Independence and Larimer Park Renovations

Bid # 24-06

ADDENDUM No. 1

March 6, 2024

Sheet C203: Grading Plan

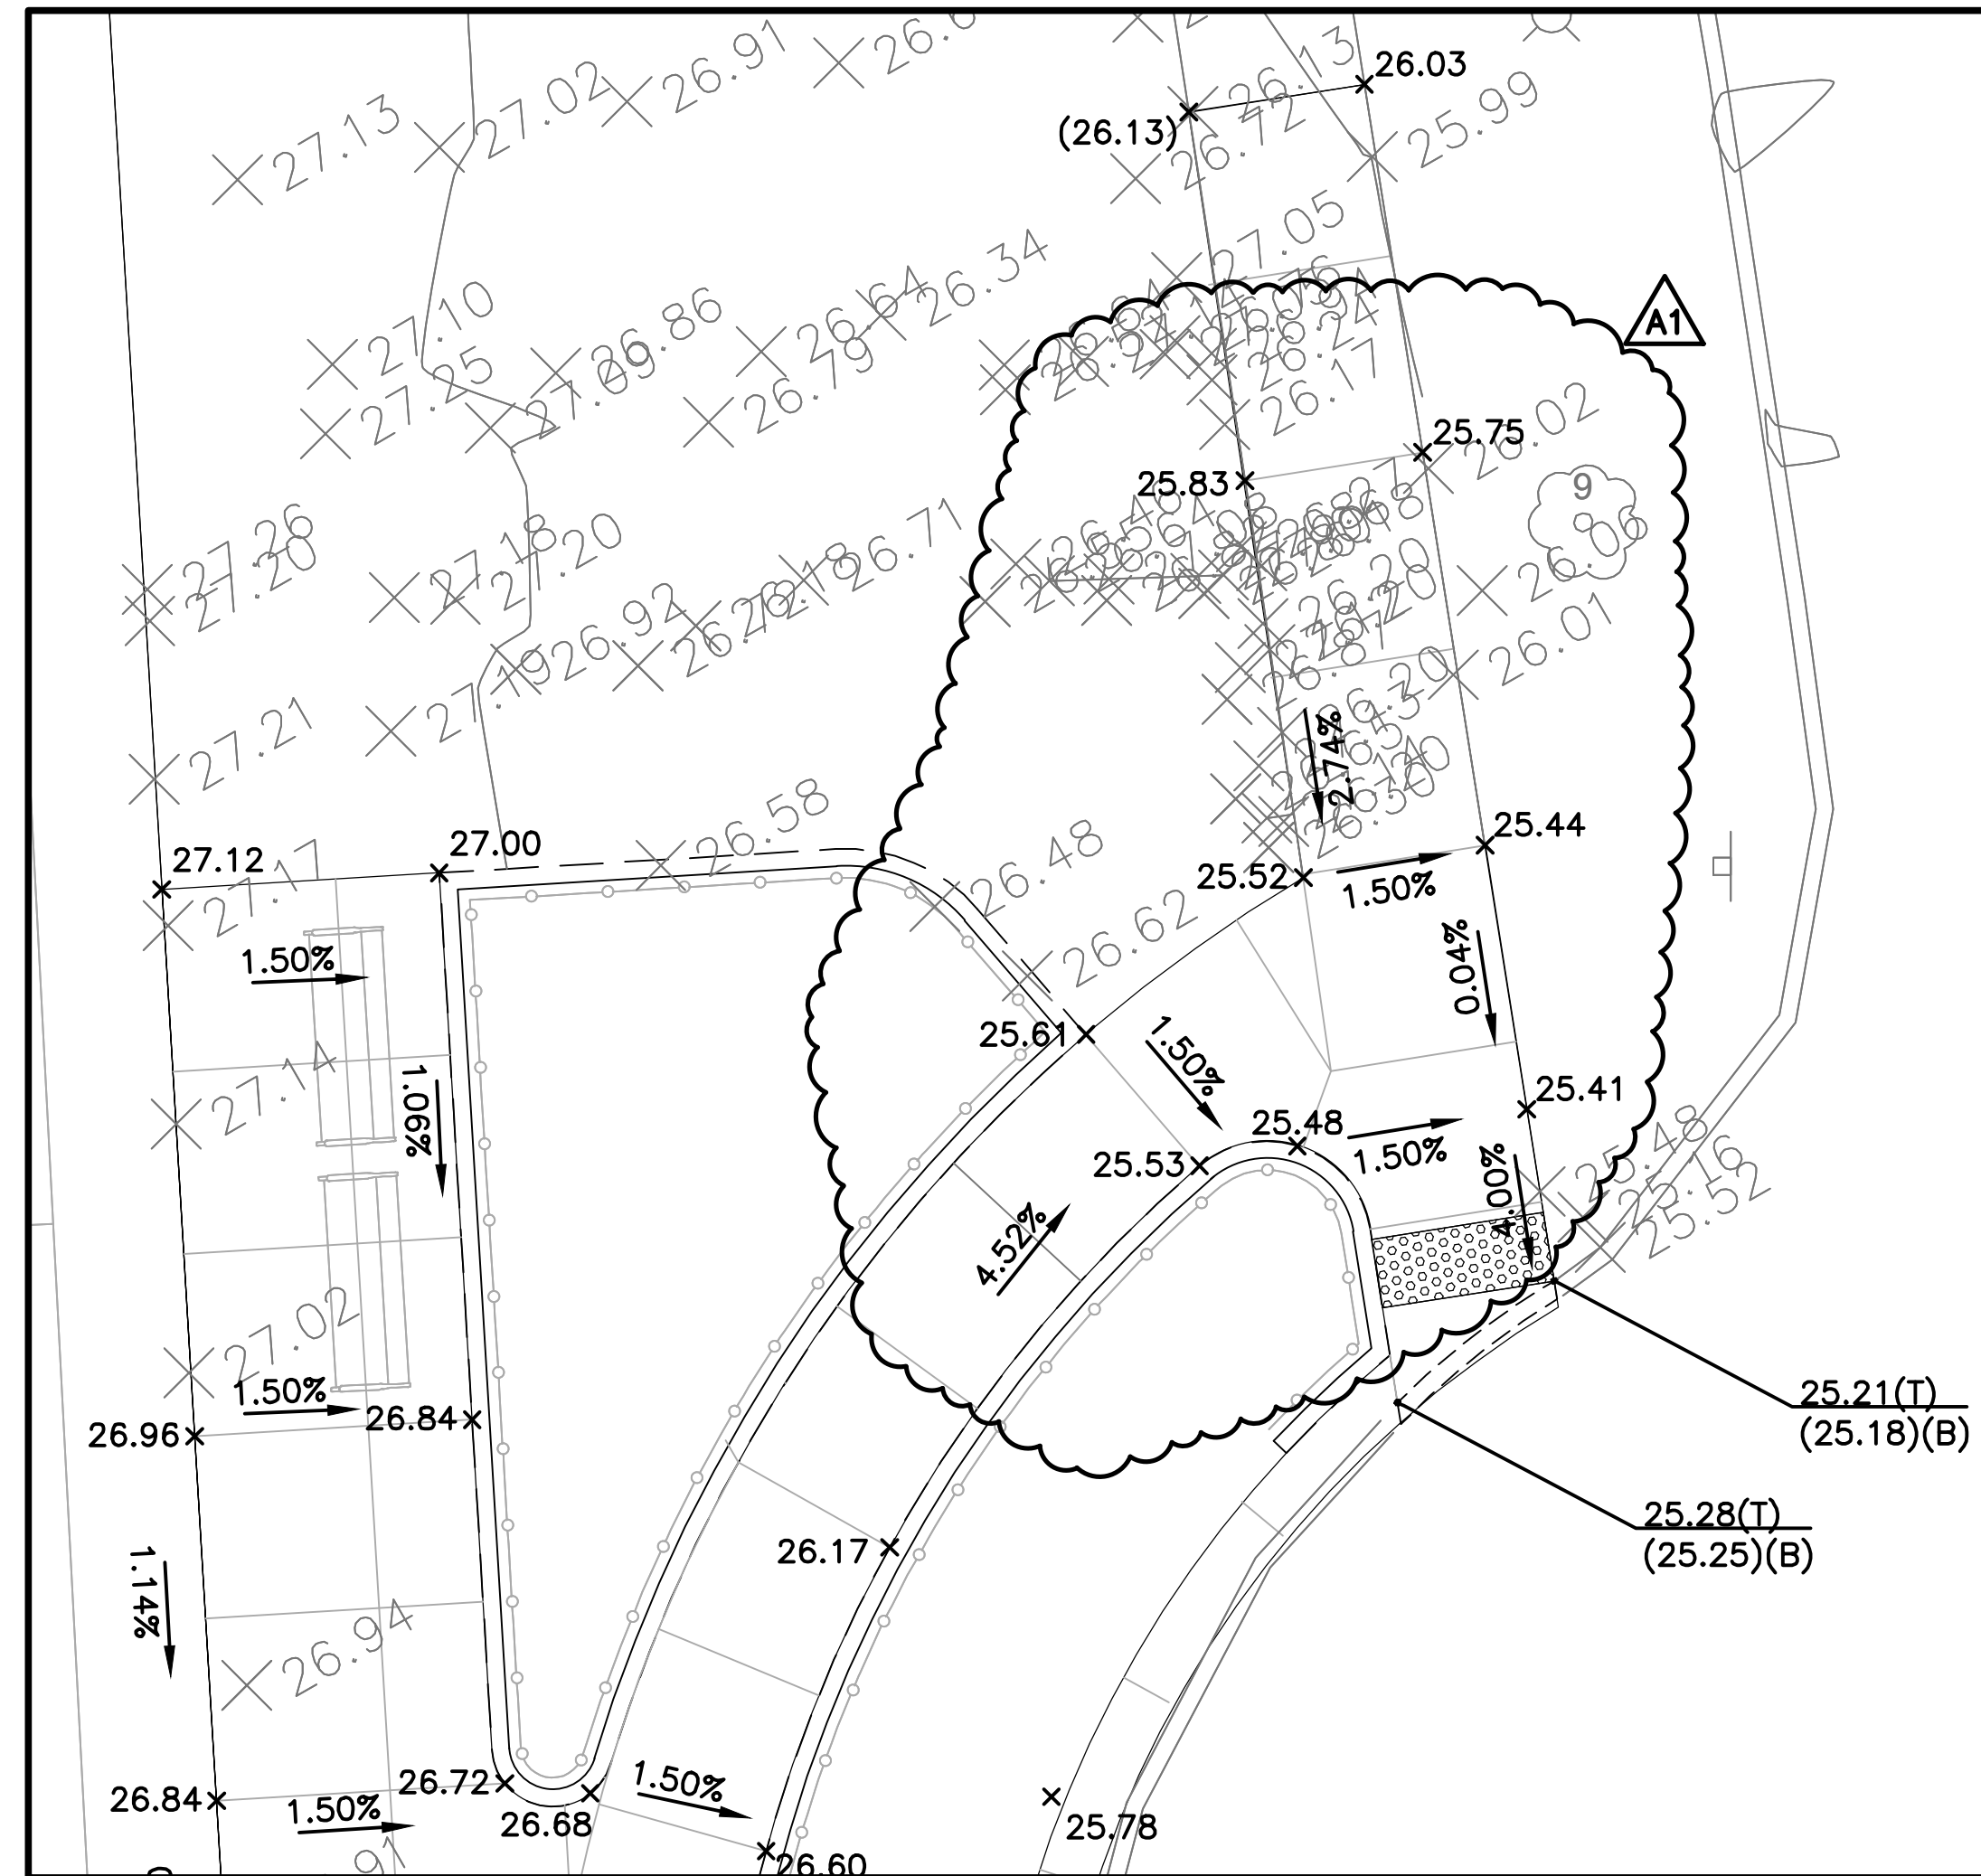
- Grades have been revised at the northwest cul-de-sac ada ramp

1 NORTHWEST CUL-DE-SAC ADA RAMP
C204 SCALE: 1"=5'

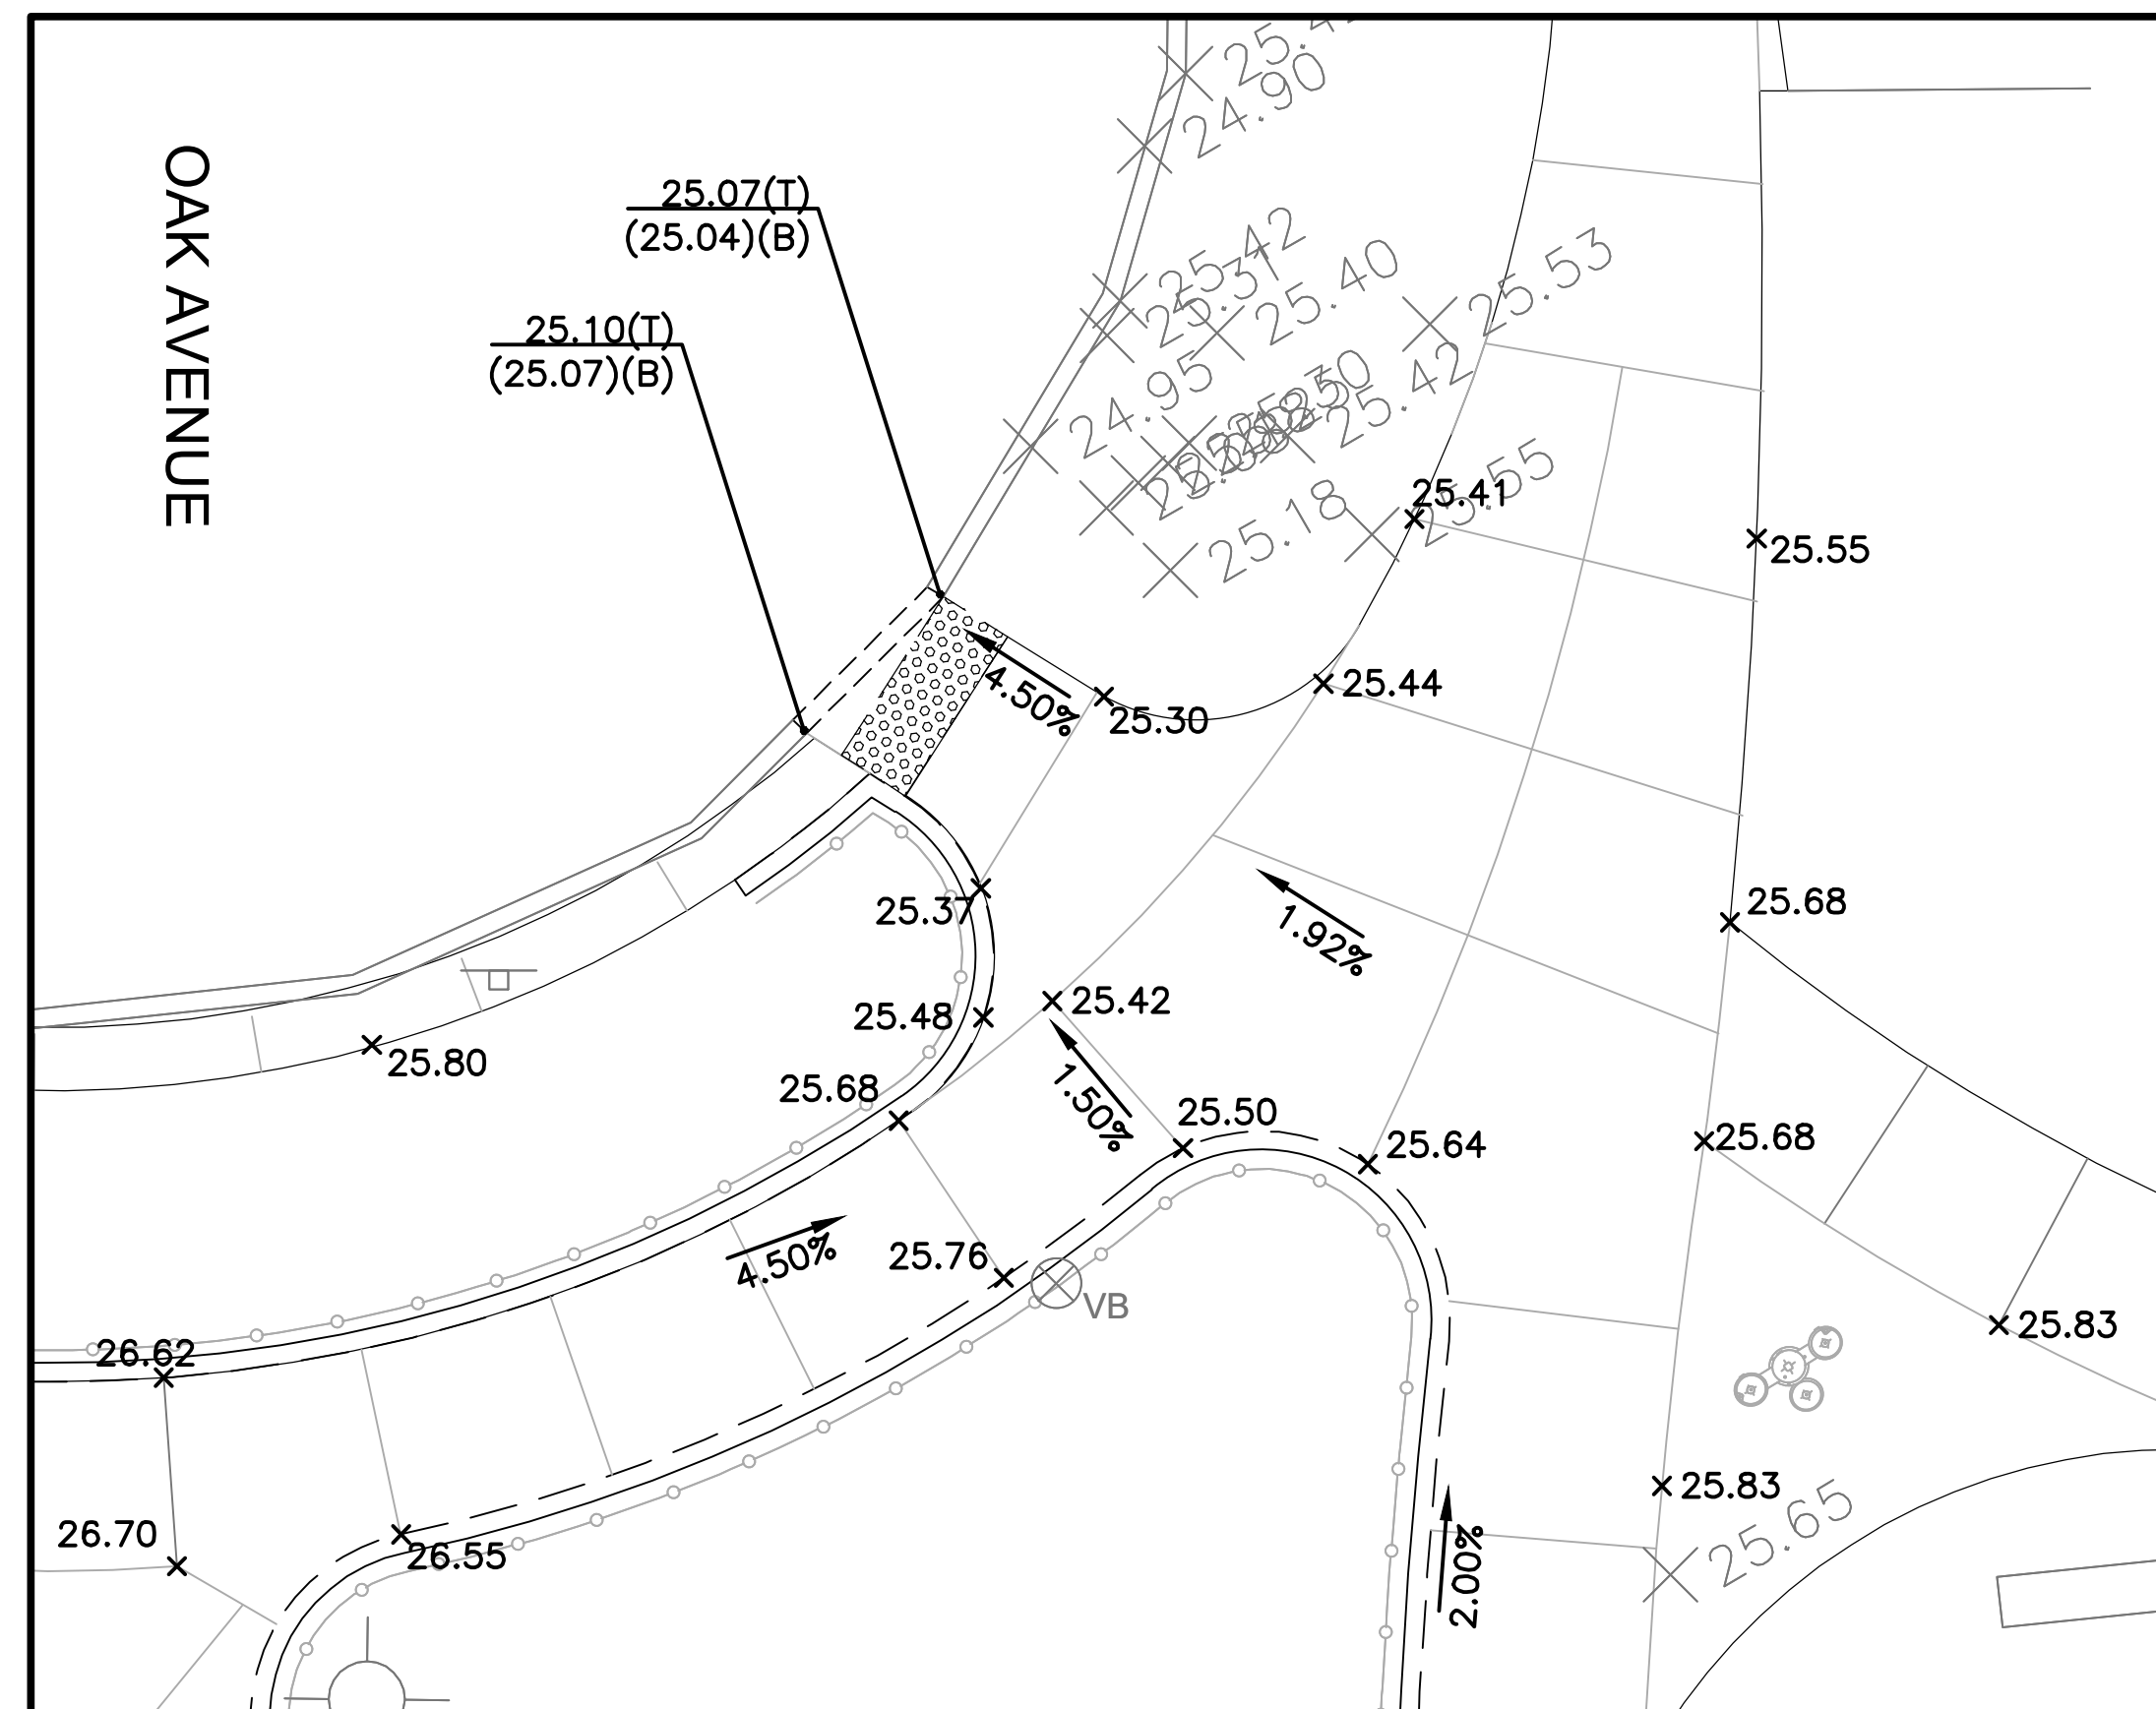
Sheet C204, Detail 1: Grading Plan ADA Details

- Grades have been revised at the northwest cul-de-sac ada ramp

2 TREE GRATE - AT EXISTING CURB
SCALE: 1" = 1'-0"

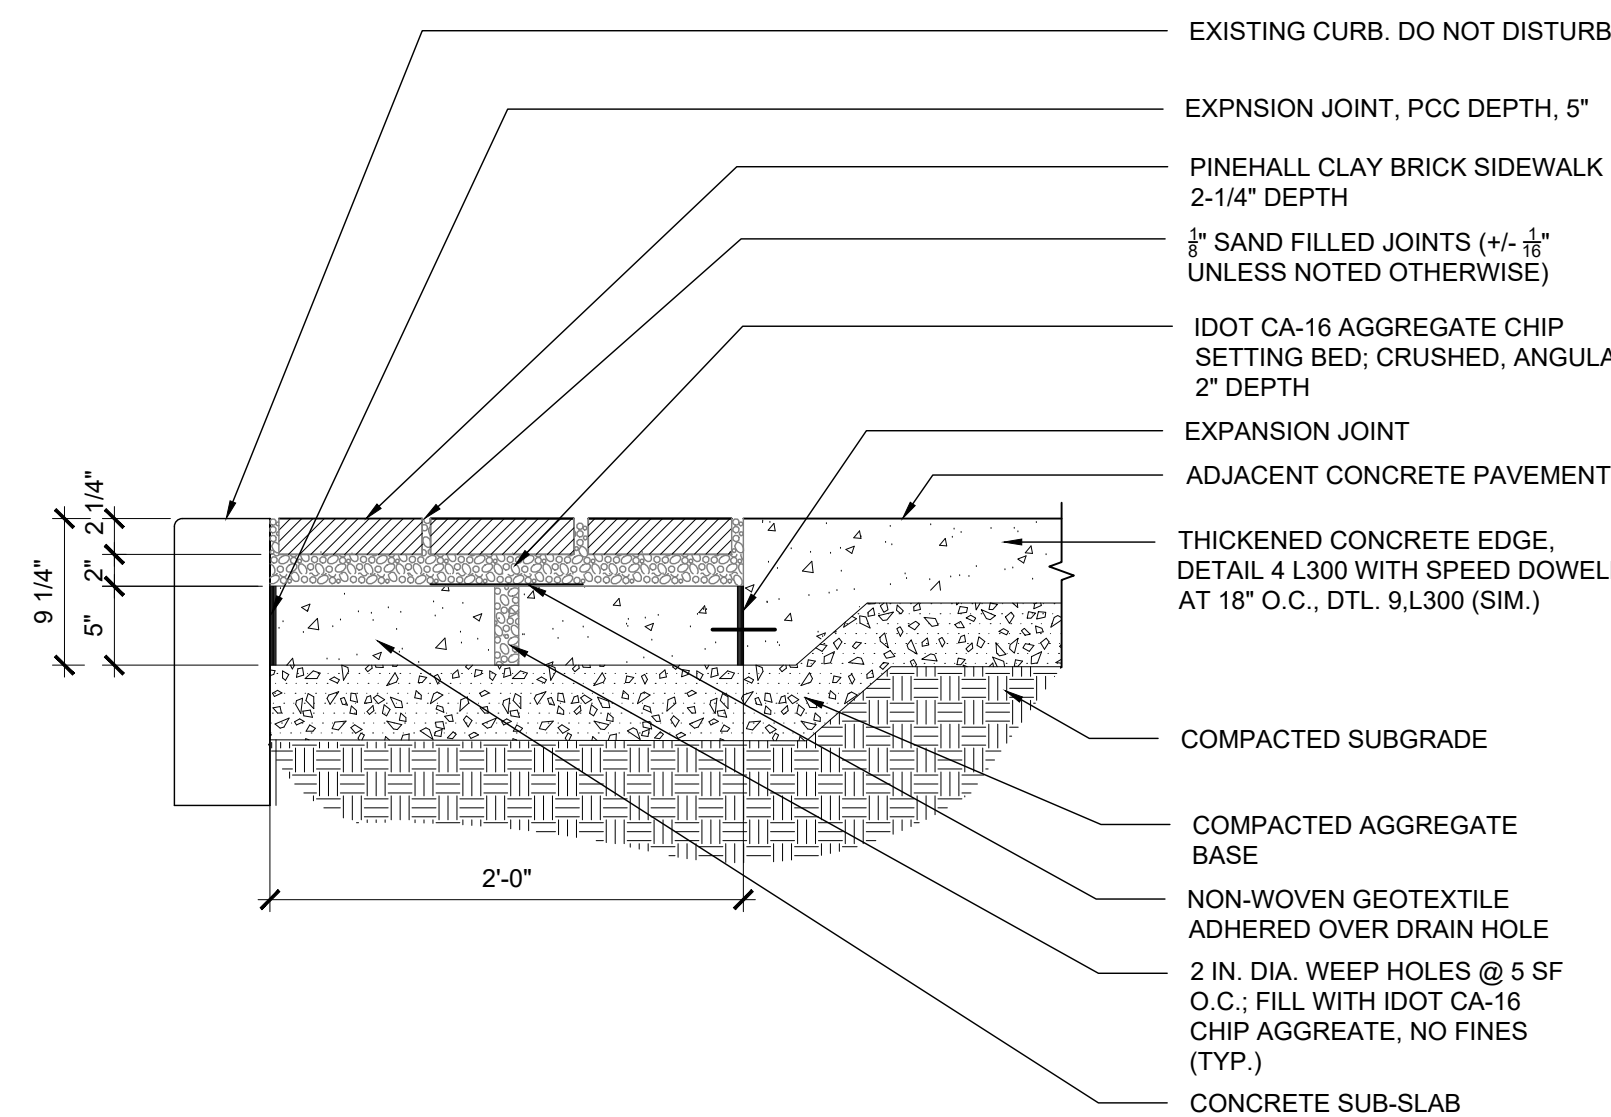
Sheet L301, Detail 2: Tree Grate – At Existing Curb

- Depth of tree rootball has been revised
